Obstructed Fuel Line Connector – Mariner/Mercury 8-200 Models

Fuel line connector P/N 22-13563A3 may have excess plastic in the fuel passageway inside the housing. Excess plastic may prevent full coupling of the fuel line to the outboard fuel connector and/or restrict fuel flow to the engine. Outboards and service stock listed require inspection of fuel line connector.

Figure 3. Obstructed Fuel Connector 50943

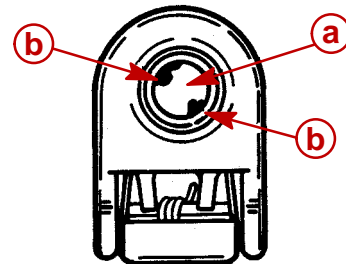
- a - Brass Piece Partially Visible
- b - Excess Plastic in Passageway

Inspect for excess plastic in passageway by looking into connector from fuel line barbed end. Brass piece on opposite end of connector should be fully visible. If brass piece is not visible, the connector is defective and must be replaced.
